Firmware Updates Information 01.04.2012

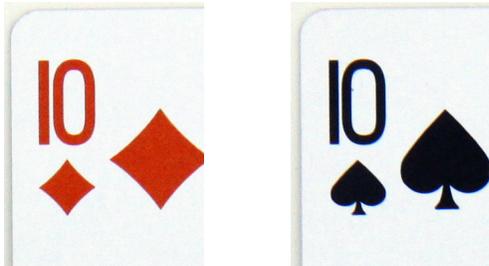
- Corrected recognize cards when something is touching the symbol on the right side:

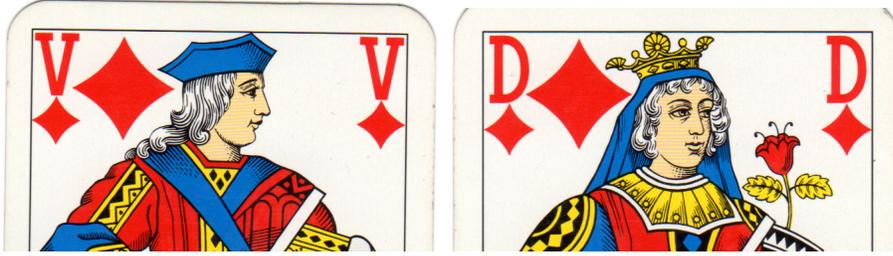
- Improved algorithm for cards with outside frame
- Changed recognition algorithm for cards when card index touches inside frame
